To: Meredith Gruber, Town of Rolesville Planning Director
From: Marty Bizzell, PE, CPESC
Date: May 17, 2022
RE: Cobblestone Village 8th Review
SP 21-01

As engineers of record, Bass, Nixon and Kennedy offers the following responses to the comments for the above referenced project:

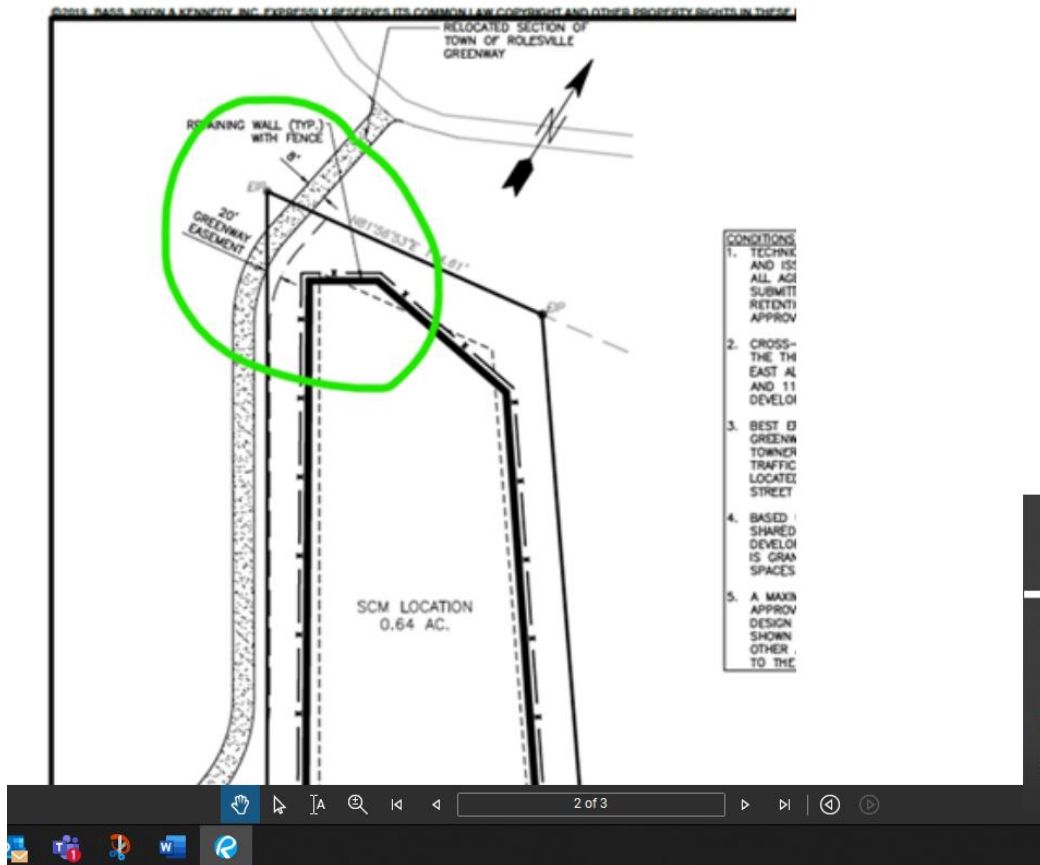
1. While the Town suggested/requested a crossover connection further south (see red line in image below), I believe Charles noted some obstacles in trying to connect there. If it's staying where it is now on the drawings, could we get the explanation to document why it is staying there (shown in the green encircled area below)? The plans don't have to be revised, just respond in writing saying, i.e., "The greenway connection to the park from the site could not be extended south of Building 7 because..."

BNK Response: There are conflicts in the area, i.e., storm drainage and sewer pump station for Bldg. 7. We request keep the location as shown.

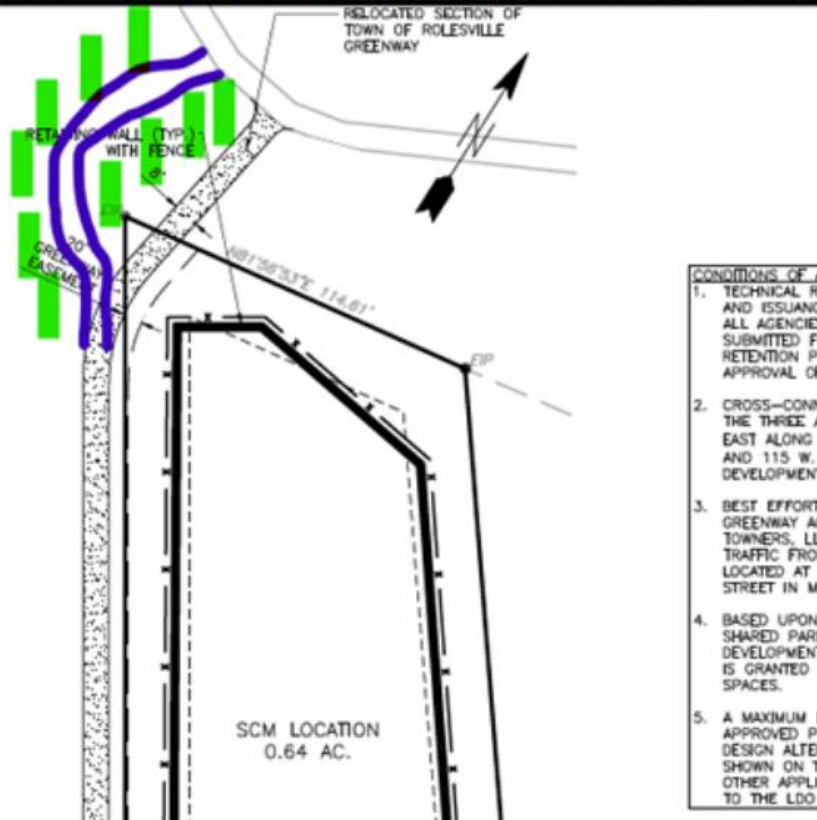
2. For the northwestern tip (see image below), this needs to be corrected as when we walked it, we marked a pathway further to the west, going around the site's property before connecting with the existing trail north. We need to have this accurate on the drawings. Also, there was talk of going back and planting trees along the area that will be cleared, could those be shown as well, i.e., #, type, and spacing of the trees?

The new trail will be more in line with this blue pathway below (and the green is for potential trees).

BNK Response: *The greenway has been shifted as requested, and 18 large canopy trees have been added along the trail.*
